DOE is providing this redline document in accordance with its obligations under Executive Order 12866 to identify the substantive changes between the draft submitted to OIRA for review and the action subsequently announced.

10 CFR Part 460

Energy Conservation Program: Energy Conservation Standards for Manufactured Housing

ACTION: Final Rule.

Figure IV.1: Annual Energy Cost Savings under the ~~Standards~~Standard

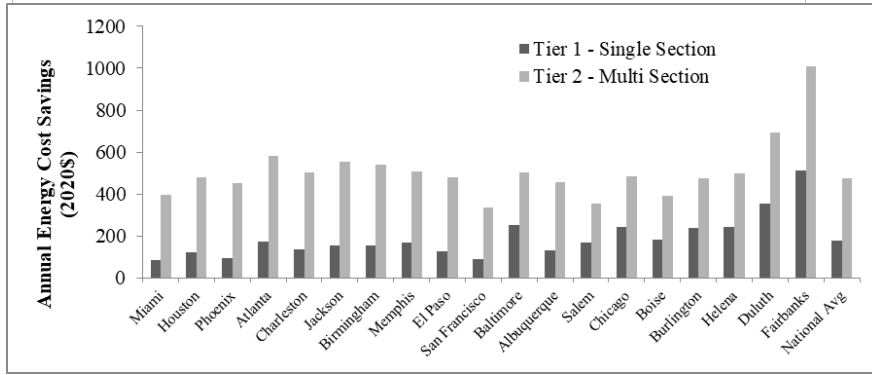
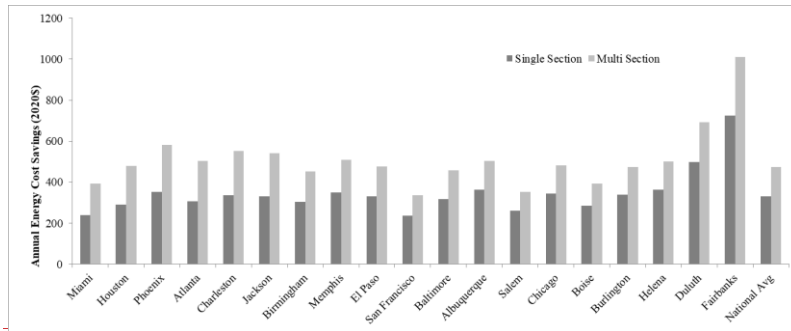
Figure IV.1 illustrates the average annual energy cost savings for space heating and air conditioning for the first year of occupation by geographic location under the standards based on the estimated fuel costs provided in chapter 8 of the Final rule TSD.

Figure IV.2: Thirty-Year Life-cycle Cost Savings under the StandardsStandard

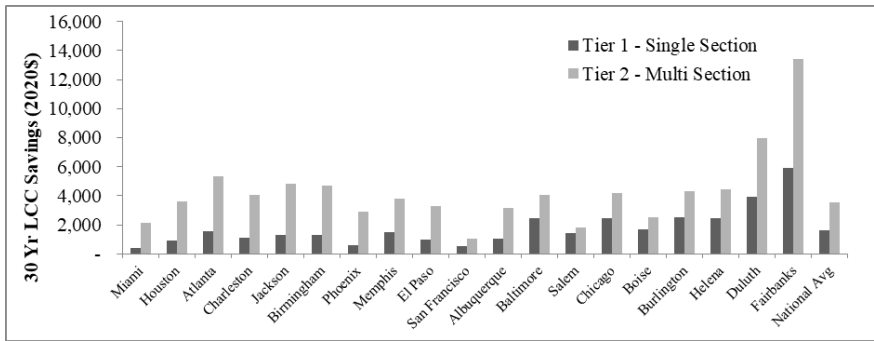
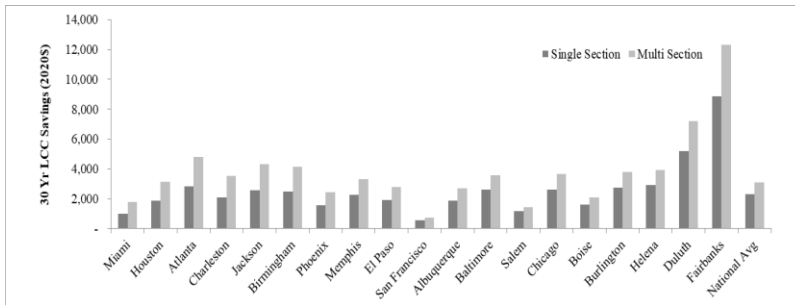
Figure IV.2 illustrate the average 30-year LCC savings by geographic location (averaged across the five different heating fuel/system types) associated with both single-section and multi-section manufactured homes. As discussed in detail in chapter 8 of the final rule TSD, the results presented account for LCC savings and impacts over a 30-year period of analysis, including energy cost savings and chattel loans or conventional mortgage payment increases discounted to a present value using the discount rates discussed in chapter 4 of the final rule TSD.

Figure IV.3:3 Ten-Year Life-cycle Cost Savings under the StandardsStandard

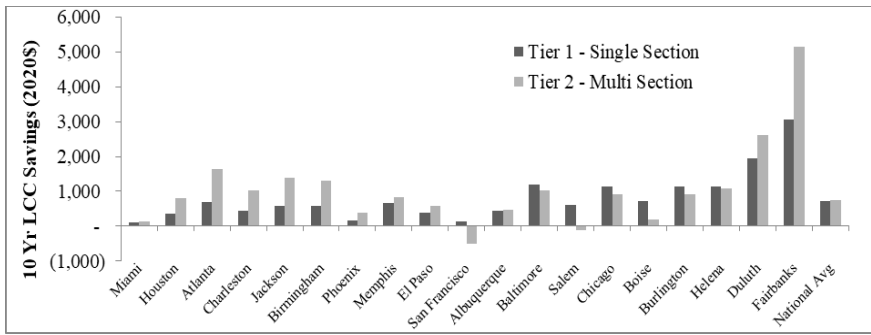
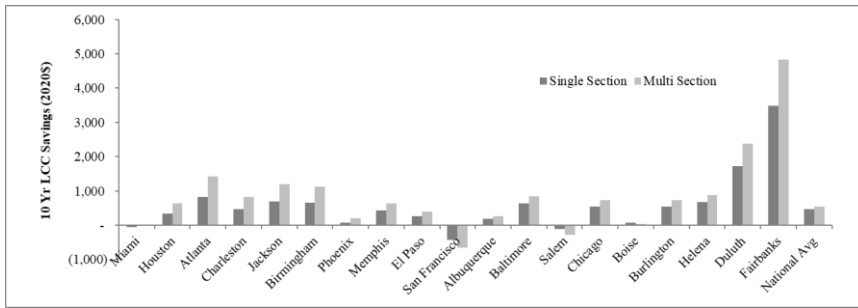
Figure IV.3 illustrate the average 10-year LCC savings by geographic location (averaged

Figure IV.3: Simple Payback Period Under the Standard

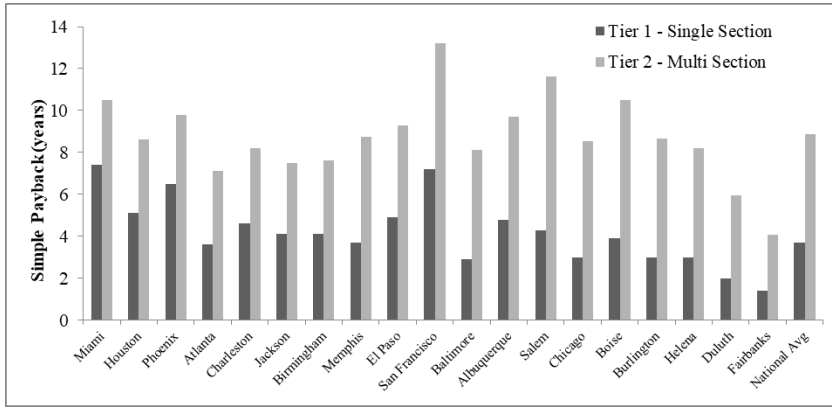
[Table IV.5 and Figure IV.4](#) Table IV.7, [Error! Reference source not found.](#), and [Figure IV.3](#) illustrate the nationwide average simple payback period (purchase price
